## ***Interactive comment on “Assimilation of citizen science data in snowpack modeling using a new snow dataset: Community Snow Observations” by Ryan L. Crumley et al.***

DUE January 25th, 2021 Reviewer Comments and Responses

Reviewer #2:

**Fig. 1.** Figure RC1

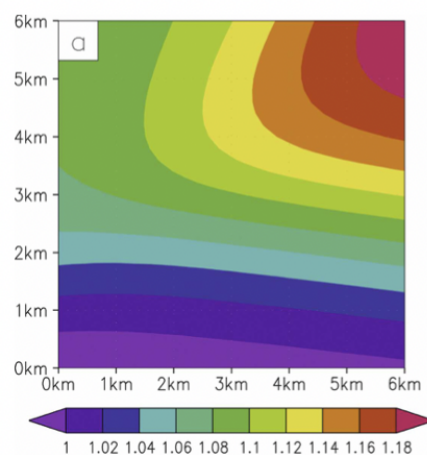
The methods section provides only a limited description of how the model is adjusted for mismatch with observations (“SnowAssim aggregates all the assimilated observations by date and creates a spatially varying correction surface that covers the entire model domain (Liston and Elder, 2008). These various correction surfaces are applied by adjusting the model precipitation fluxes and snowmelt factors between SWE observation dates during a second SnowModel simulation”). The ‘adjustments’ to the model are central to the effort, so the method should be described more completely in the manuscript.

The authors note that the literature on SnowAssim (Liston and Heimstra, 2008) is cited in the methods section 3.2.4 and we make efforts to not repeat information from that publication. First, see Figure RC1 (Figure 6a from Liston and Heimstra, 2008) included in our response below for the reviewer’s ease, as an example of a correction surface referenced above. We do not include an example of the correction surface in the manuscript because it is explained in the original literature. However, see the previous answer for additional information that will be added to the manuscript’s method section 3.2.4.

Figure RC1: This is Figure 6a from Liston and Heimstra (2008) showing an example of a spatially distributed correction factor surface created by the *SnowAssim* data assimilation scheme. These values modify the 1) precipitation inputs during the accumulation phase or 2) the melt rates during the ablation phase. We do not intend to add this figure to the manuscript.

Fig. 2. Figure RC2

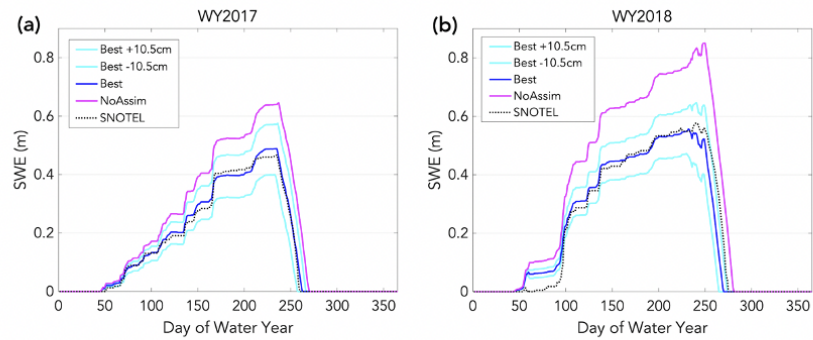
Second, uncertainty of the observations and validation data should be described and incorporated into the analysis. One of the benefits of DA is that the magnitude of uncertainty can be explicitly included in the analysis (e.g., Magnusson et al., 2014 and 2017). It appears that uncertainty of the assimilated observations is not included in the analysis – is this the case? If not, why not?

The spatial representativeness of the depth measurements is mentioned in the discussion. One component of uncertainty is related to the conversion from depth to SWE, using the density estimation described in Hill (2019). In the region analyzed, SWE estimates based on density from Hill (2019) have an RMSE of 0.2-0.25 (normalized to snow season precipitation). Is this considered in the DA approach? Uncertainty (or biases) of the validation data is not described, thus it is implied that the data are 'perfect'. What is the error or uncertainty associated with the federal sampler data?

One of the sources of uncertainty mentioned by the reviewer comes from the conversion of snow depth to SWE using the Hill et al. (2019) method. We can quantify this source of error using the reported values from Hill et al. (2019) or using the fieldwork measurements of co-located snow depth and SWE (see Table RC2 above). Another source of uncertainty is the spatial representativeness of the depth measurements across short distances. The average standard deviation of snow depth at all 70 fieldwork sites is 22 cm of snow depth, and after conversion to SWE, the average is 8.7 cm of SWE. We can assume that the spatial variability of snow depth plays a role in the conversion method uncertainty, so we decided to choose one of these values and perturb SWE measurements used in the data assimilation scheme. In an attempt to be conservative with our error estimates, we chose the highest reported/measured error value of 10.5 cm to create an envelope of uncertainty around our SWE values reported in the assimilation runs at the Upper Tsaina SNOTEL station. Figure RC2 contains the results of these additional model runs. This uncertainty analysis displays improved

simulation results, even after the error estimation from these sources of uncertainty have been taken into consideration. This figure further contextualizes the temporal results in section 6.1 and we suggest adding it to the manuscript with the following sentences.

"Using the snow depth to SWE conversion method during assimilation introduces uncertainty into the modeling process. Instead of using the global estimates of error reported in Hill et al. (2019; RMSE in SWE = 5.9 cm) we decided to calculate this source of error using our fieldwork site measurements. The RMSE in SWE due to the conversion method is 10.5 cm and we perturbed the CSO observations by this amount to depict the upper and lower boundaries of error associated with this source of uncertainty. Figure [RC2] displays the Best CSO simulation temporal results for each WY, along with the UTS station SWE record and the NoAssim case. These perturbations to the assimilated SWE show improved modeled SWE values at the UTS station when compared to the NoAssim case, even after this source of uncertainty has been accounted for."

Figure RC2: Snow water equivalent (SWE) time series results with measurement uncertainty included. The simulations with  $\pm 10.5$  cm of SWE represent the upper and lower boundaries of error introduced when converting snow depth measurements to SWE using the Hill et al. (2019) method.

Fig. 3. Figure RC3

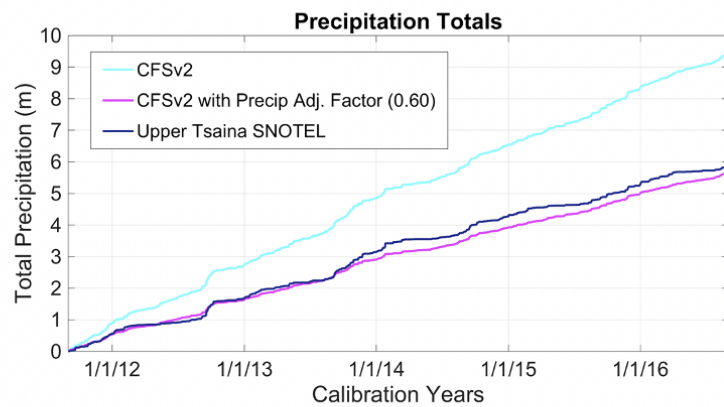
Third, something seems strange about the calibration and validation methods and results. Are the NSE values in Table 1 correct? If the best simulation has  $NSE < 0$ , this would suggest that the calibration is not working very well. Additional details are required.

The values in Table 1 in the original manuscript are correct and they were the impetus for including the precipitation adjustment experiment in the manuscript. The initial calibration model runs and the final No Assimilation model runs were displaying time-series SWE values that were consistently high, throughout both water years, with both reanalysis products (see original Figure 5a and 5d). We know that biases in meteorological forcings are one of the most important factors in estimating snow depth and SWE magnitudes correctly (Liston and Heimstra, 2008; Margulis et al., 2015). So we decided to take a closer look at the precipitation totals with the CFSv2 product. See Figure RC3 that shows the total amount of precipitation over the calibration period when compared to the Upper Tsaina Snotel station and compared to when a precipitation adjustment factor is used. The authors would like to add this figure to the appendix to clarify the need for precipitation adjustments, whether via data assimilation or the precipitation adjustment experiment.

Because of this bias in the meteorological inputs, and after a conversation with the model developer about the calibration challenges in this region of Alaska, the authors were confident that making adjustments to the model parameters would only slightly improve our snow depth and SWE distributions and magnitudes (see Appendix A for a full list of the model parameter adjustments made during calibration). The improvements that could be made by adjusting model parameters were insignificant when compared to adjusting the precipitation fields.

Figure RC3: Precipitation totals at the Upper Tsaina SNOTEL station compared to the CFSv2-forced model totals and the CFSv2-forced model totals with a precipitation adjustment factor. This overestimation of precipitation by the reanalysis product is a major factor in the quality of the calibration results.
